BOLTON PLANNING & ZONING COMMISSION
Regular Meeting
7:30 p.m., Wednesday, April 13, 2022
Virtual
Minutes & Motions

a. Special Permit Application for Gas Station/Convenience Store, 271 Hop River Road, Nathan Fleming (#PL-22-2)

Site Plan

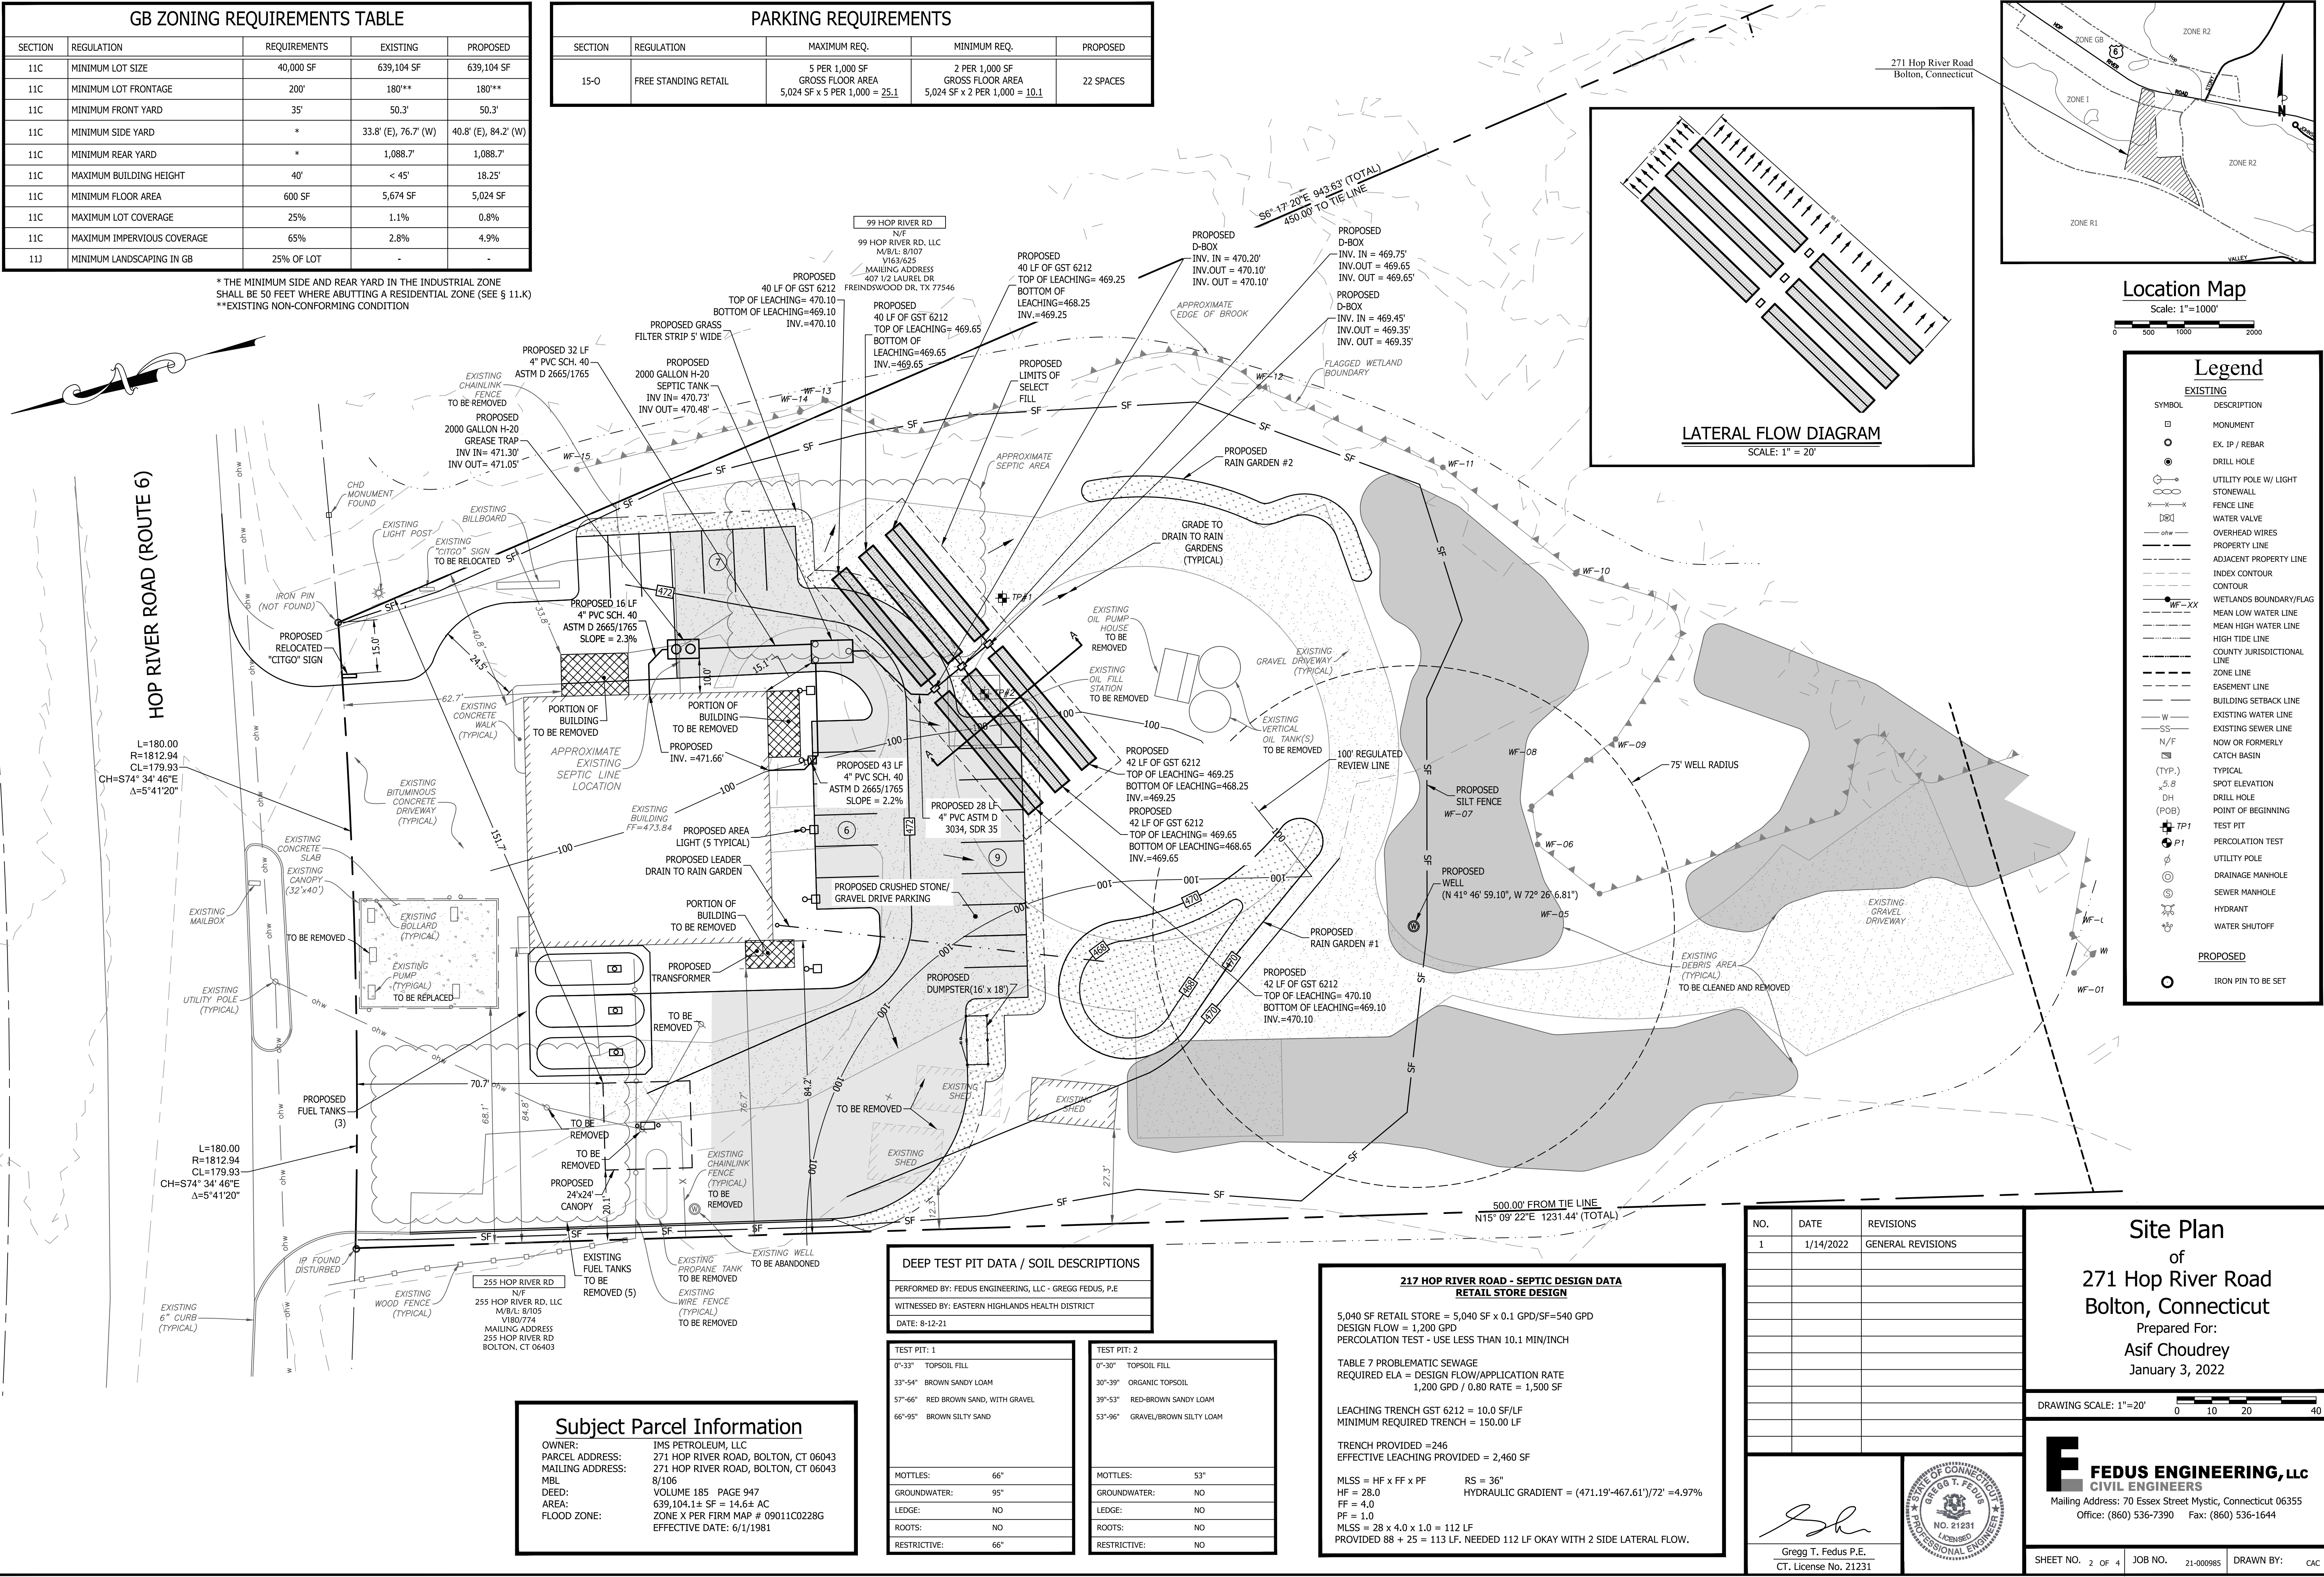
8. The site plan proposes 22 parking spaces. A minimum of one van-accessible parking space should be provided. – **Addressed on Site Plan sheet 2 of 5.**

SHEET NO. 4 OF 5	JOB NO. 21-000985	DRAWN BY:
------------------	-------------------	-----------

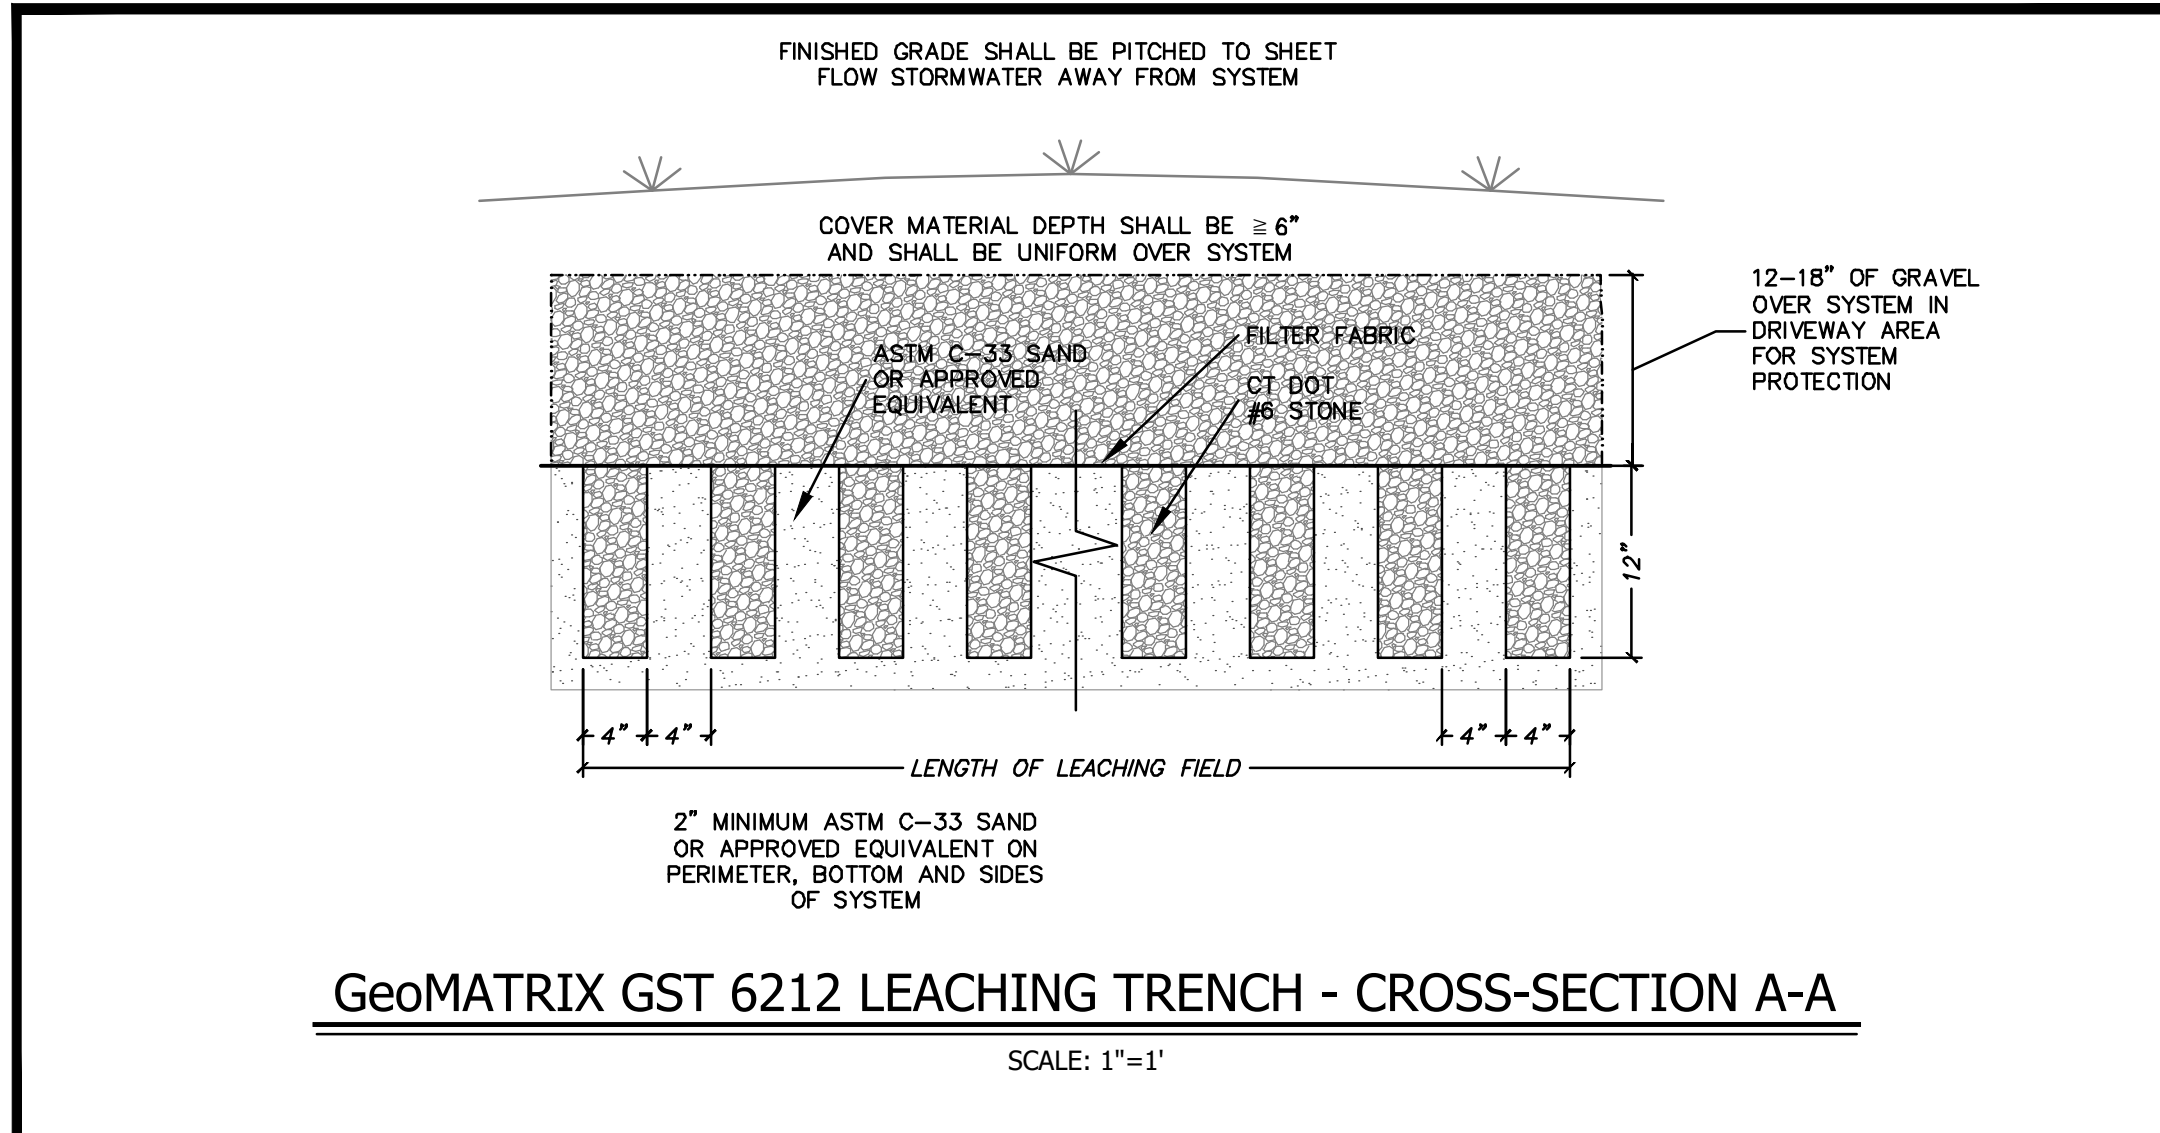
1. The MLSS calculation requires a perc test in the naturally occurring soil, at TP2 its 39-53 inches. – **Percolation tests added to Site Plan. Sheet 2 of 5.**
2. Provide clear existing contour lines over the leaching area or spot elevations. – **Addressed on the Site Plan. Sheet 2 of 5.**
3. The leaching row elevations on sheet 2 are inconsistent with the cross section detail on sheet 4, mislabeled. – **Addressed on Detail sheet and Site Plan.**
4. Indicate cleanouts in sewer lines, change of directions > 45 degrees. – **Addressed on Site Plan. Sheet 2 of 5.**
5. Provide Geomatrix detail sheet for GST H20 loading. – **Added to Sheet 5 of 5.**

6. Consider a level distribution system for uniform distribution. – **Redesigned for level distribution system.**
7. Select fill placement is proposed to the mottling elevation. Observations for groundwater were made in August. Placing select fill to the groundwater level made create a conduit for vertical movement of ground water. Check groundwater conditions prior to construction. – **Note added on Sheet 5 of 5.**
